DEVELOPMENT PERMIT PANEL:
RIVA 5 & 6

JULY 15, 2026

YAMAMOTO ARCHITECTURE

CHANGES & REVISIONS

PLANTER WALL HEIGHT ADJUSTMENT

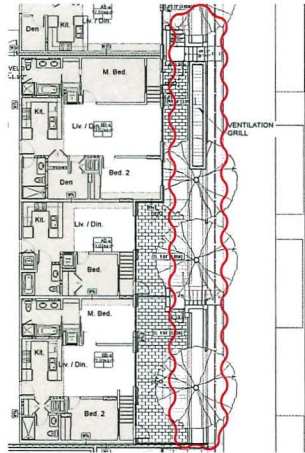
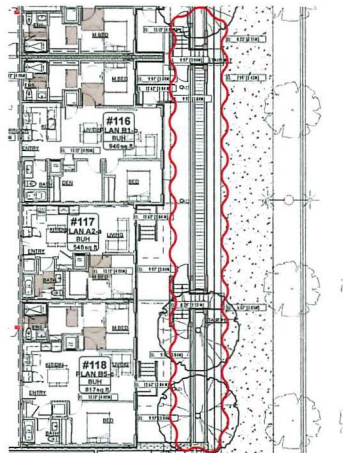
PLANTER HEIGHT RAISED BY
PROPOSED
